<b>Company</b>	Trenz Electronic GmbH
<b>PCN Number</b>	PCN-20190503
<b>Title</b>	TE0790-02-* to TE0790-03-* Hardware Revision Change
<b>Subject</b>	BOM change
<b>Issue Date</b>	2019-05-07

This change affects the Trenz Electronic product TE0790 of revision 02: TE0790-02

### #4 LEDs replaced

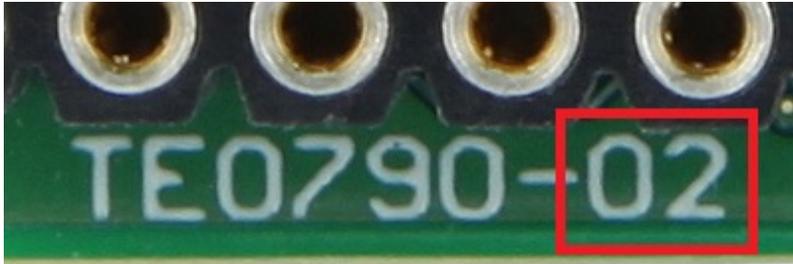
**Type:** BOM/PCB Change

**Reason:** Old LEDs are obsolete

**Impact:** New LEDs have 0603 package instead of 0402.
